Braidwood Station, Units 1 and 2
Facility Operating License Nos. NPF-72 and NPF-77
NRC Docket Nos. STN 50-456 and STN 50-457

Byron Station, Units 1 and 2
Facility Operating License Nos. NPF-37 and NPF-66
NRC Docket Nos. STN 50-454 and STN 50-455

Subject: Response to NRC Requests for Additional Information, Set 4, dated December 12, 2013, related to the Braidwood Station, Units 1 and 2, and Byron Station, Units 1 and 2 License Renewal Application

**Byron and Braidwood Stations (BBS), Units 1 and 2
License Renewal Application
Responses to Requests for Additional Information**

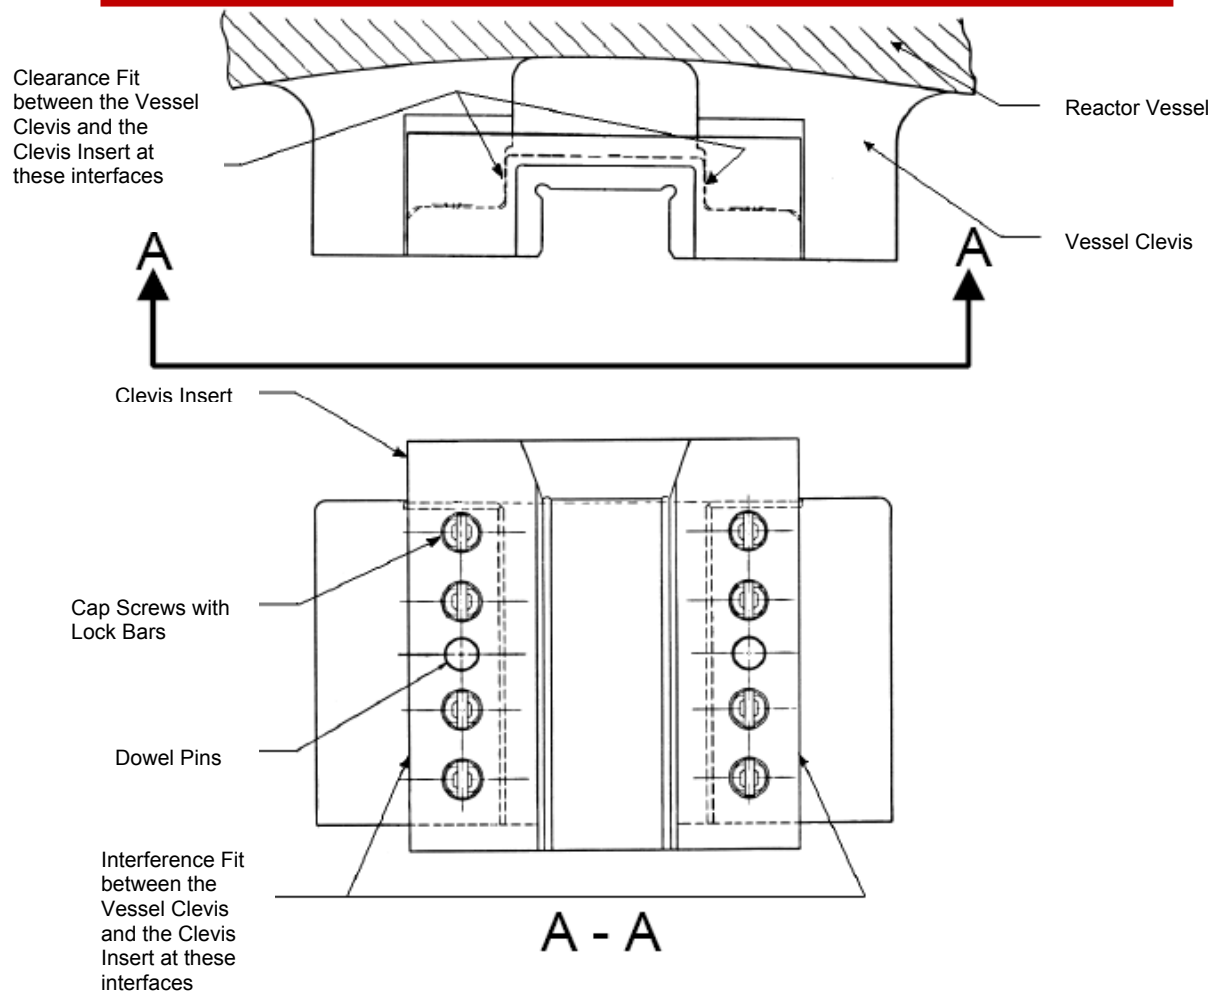
1. Specify the fabrication material, including any applicable heat treatment, for the clevis insert bolts at Byron and Braidwood, Units 1 and 2.
2. Discuss and justify whether the operating experience associated with cracking of the clevis insert bolts (discussed above) is applicable to Byron and Braidwood Stations, Units 1 and 2.
 - If applicable, discuss and justify how your PWR Vessel Internals Program will be augmented to require an inspection of the clevis insert bolts capable of detecting cracking. If the PWR Vessel Internals Program will not be augmented, provide a technical justification for the adequacy of the existing VT-3 visual inspection to detect cracking before it results in clevis insert bolt failure.

- Precipitation hardened at $1350 \pm 15^{\circ}\text{F}$ ($732 \pm 8^{\circ}\text{C}$), hold for 8 hours, furnace cool to $1150 \pm 15^{\circ}\text{F}$ ($621 \pm 8^{\circ}\text{C}$), hold until total precipitation heat treatment has reached 18 hours, air cool.

This heat treatment is similar to that which is typically referred to as low-temperature annealed and aged condition (BH).
